# Access Compliance Report

## Public Rights-of-Way

### (Curb Ramps)

Intersection ID: 11921	Main Street: COUNTRY CLUB DR	Cross Street: VENTOSA DR	Location: NW
ADA ID: C672929CBA49	Ramp Type: Perp	Initial Pass/Fail: Fail	Overall Compliance: No
Severity Score: 42.5			
Codes/Mitigation Info/Possible Solution		Field Measurements/Component Compliance

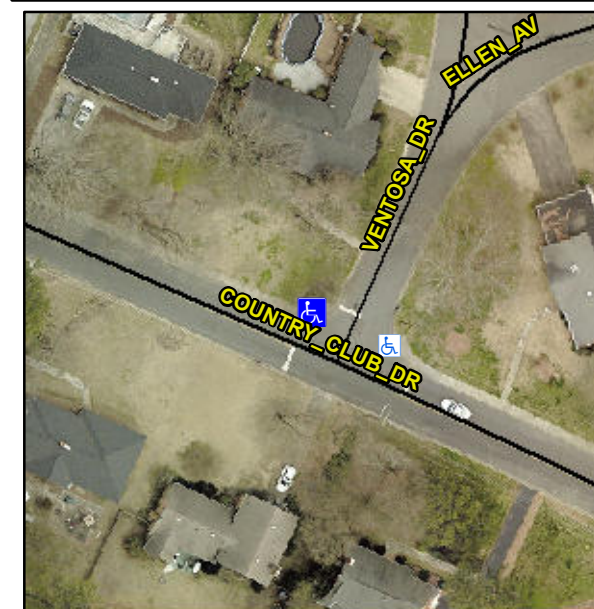
**Remove & Replace Entire Ramp.**

**Not Found, R304.5.1, R304.2.2**

Compliance	Description	Data	Compliance	Description	Data
N/A	Ramp Length (in)	63.0	No	Ramp Slope (%)	14.6
No	Ramp Width (in)	32.0	Yes	Ramp XSlope (%)	0.9
N/A	Flare Type LT	N/A	N/A	Flare Type RT	N/A
N/A	Flare Slope LT (%)	N/A	N/A	Flare Slope RT (%)	N/A
N/A	Flare Traversable LT?	N/A	N/A	Flare Traversable RT?	N/A
N/A	Landing Length (in)	N/A	N/A	DWS Provided?	N/A
N/A	Landing Width (in)	N/A	N/A	DWS Contrast?	N/A
N/A	Landing Slope (%)	N/A	N/A	DWS Length (in)	N/A
N/A	Landing X Slope (%)	N/A	N/A	DWS Full Width?	N/A
N/A	Landing Curb? (Y/N)	N/A	N/A	DWS Offset (in)	N/A
N/A	Shared Landing?	N/A			
N/A	Gutter Ponding?	N/A	N/A	Gutter Slope (%)	N/A
N/A	Gutter Lip Ht (in)	0.5	N/A	Gutter X Slope (%)	N/A
N/A	Painted X Walk1?	No	N/A	Painted X Walk2?	N/A
	X Walk 1 Direction	To SE		X Walk 2 Direction	N/A
N/A	X Walk 1 Width (in)	N/A	N/A	X Walk 2 Width (in)	N/A
	X Walk 1 Slope (%)	1.0		X Walk 2 Slope (%)	N/A
	X Walk 1 X Slope (%)	3.8		X Walk 2 X Slope (%)	N/A
